REMOVAL ACTION GROUNDWATER MONITORING PROGRAM PLAN

GRANVILLE SOLVENTS SITE GRANVILLE, OHIO

Subject: **Granville Solvents Site Removal Action**
Submittal of Revised Groundwater Monitoring Program Plan and Responses to U.S.
EPA's Comments Dated May 12, 1995

**RESPONSE TO COMMENTS
FROM UNITED STATES ENVIRONMENTAL PROTECTION AGENCY
REGARDING GRANVILLE SOLVENTS SITE
REVISED GROUNDWATER MONITORING PLAN
DATED APRIL 11, 1995**

GRANVILLE SOLVENTS SITE GROUNDWATER MONITORING WELLS, PIEZOMETERS, HYDROPUNCHES AND EXAMPLES OF PROPOSED NEW WELLS GRANVILLE, OHIO

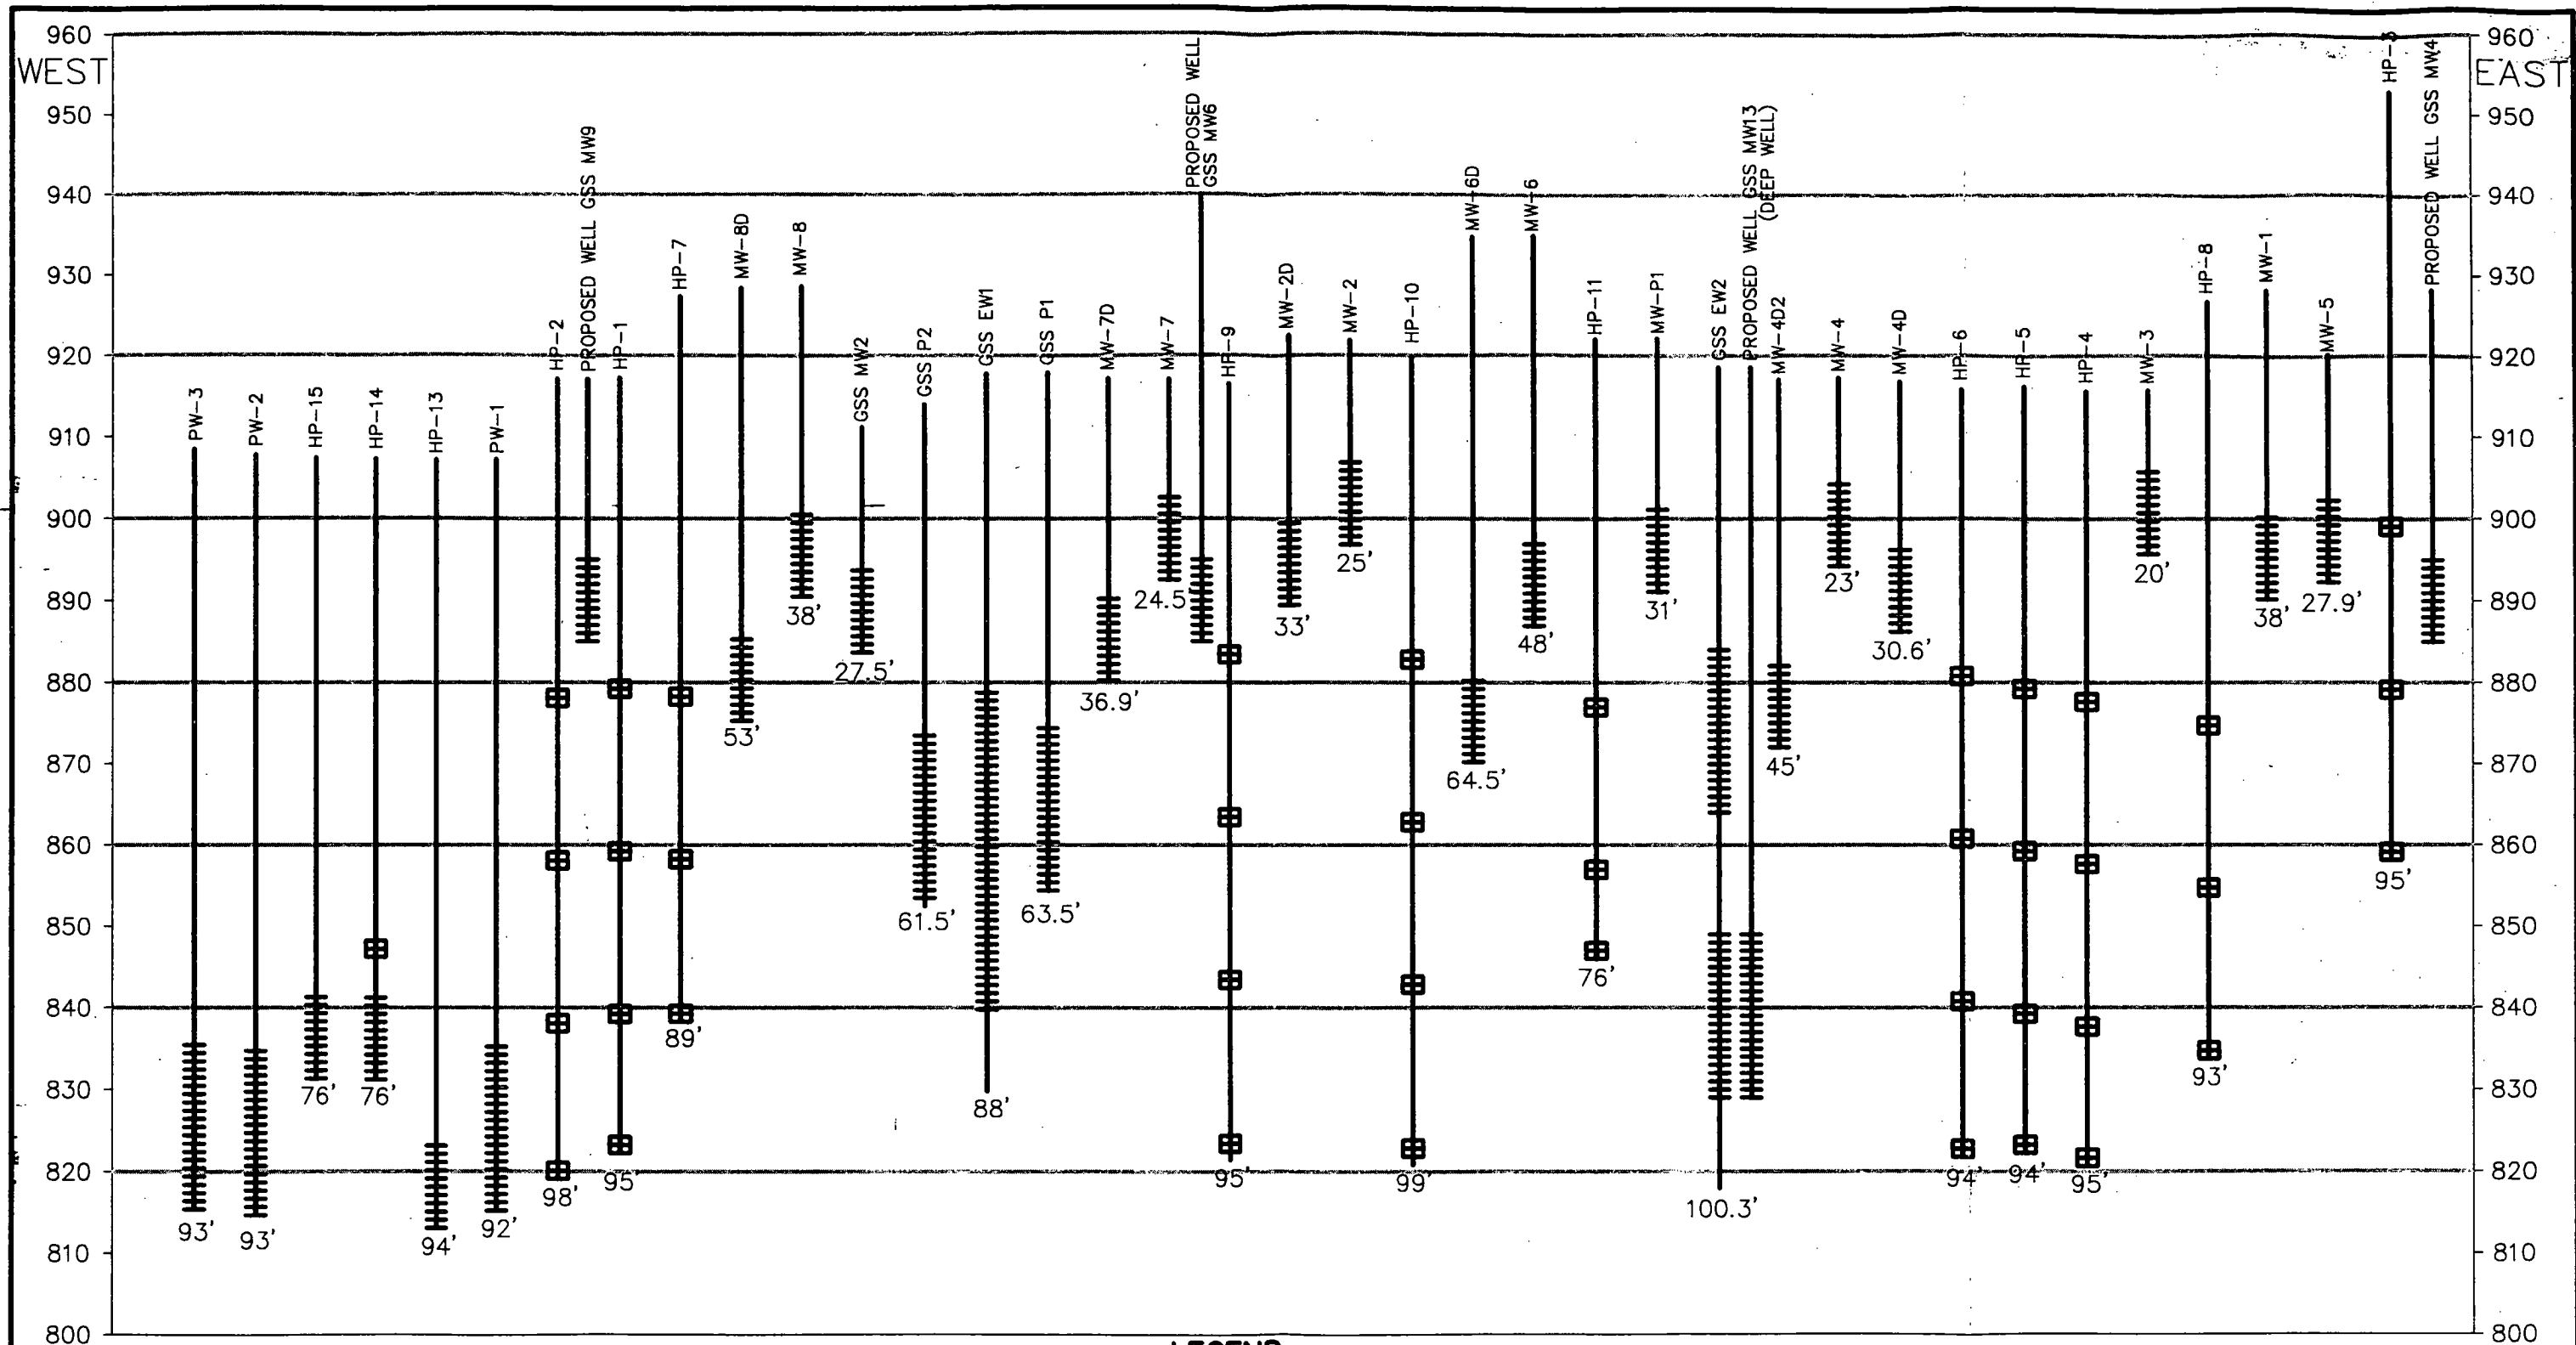
Unfortunately, questions remain regarding the vertical extent of contamination. This monitoring plan proposes two of the new wells to be screened deep and the other 10 to be screened slightly below the water table. The two deep wells will be installed next to existing wells (MW-2 nest and MW-4 nest). This will allow an evaluation of vertical gradients at a location adjacent to extraction well GSS-EW2 and at a location about 150 feet west of the extraction well. Although these two locations will assist with evaluating the effectiveness of GSS-EW2 capturing groundwater from deeper in the aquifer the picture remains incomplete. Two additional deep wells are needed, the deep well mentioned previously as part of the 2 well cluster located off the southeast corner of the site and a deep well nested with MW-1 (in the northeast portion of the site).

The remaining 10 proposed monitoring wells will be single wells and will yield no information on vertical distribution. Even with implementation of this plan, there will remain a need for additional information on vertical extent of contamination. The Monitoring Program Plan proposes to screen these wells 5 to 10 feet below the water table. To confirm the assertion that this zone represents the zone in which highest concentration levels occur at the new monitoring well locations, and to fully characterize the vertical

variation in concentration levels, the new well locations should be vertically sampled (collect groundwater samples at 10 foot vertical intervals during well installation) . Assuming that concentration levels are highest in the upper portion of the aquifer, the new shallow wells should be constructed as planned. If the highest level of contamination at a location is not found in the upper portion of the aquifer, then an additional well should be constructed, screened in the zone of highest concentrations (creating a well nest with the shallow well) .

1. The proposed locations would place three groundwater monitoring well locations covering a horizontal distance less than 200 feet. As an alternative, it is proposed to leave two wells on the eastern margin of the site as previously proposed. Within 100 feet west of the proposed location of GSS-MW3, a boring was made and groundwater collected using a Hydropunch sampling device (HP-4, Figure 1, Plates 2 through 7, Figures 3 through 8). Sample results indicated the presence of only 1,1,1-TCA at concentrations well below the MCL of 200 $\mu\text{g/l}$. The highest concentration (80 $\mu\text{g/l}$) was detected at an elevation of approximately 880 feet above mean sea level (amsl) (Plate 4, Figure 5), or 20 feet below the water table. Concentrations decreased with depth. Although not warranted based on these data, a deep well will be paired with proposed location GSS-MW3 with a screen elevation of approximately 840 to 830 feet amsl. The value of this well is in the hydraulic information that it may provide for the deeper part of the aquifer east of GSS-EW2.

As agreed, a single deep well will be installed adjacent to GSS-MW3. At the location GSS-MW11, a boring was made and groundwater collected using a Hydropunch sampling device (HP-3). Sample results indicated the presence only of 1,1,1-TCA concentrations well below the MCL (Figure 1, Plates 2 through 7, Figures 3 through 8). These results do not support the need for multiple well screen depths at this location.
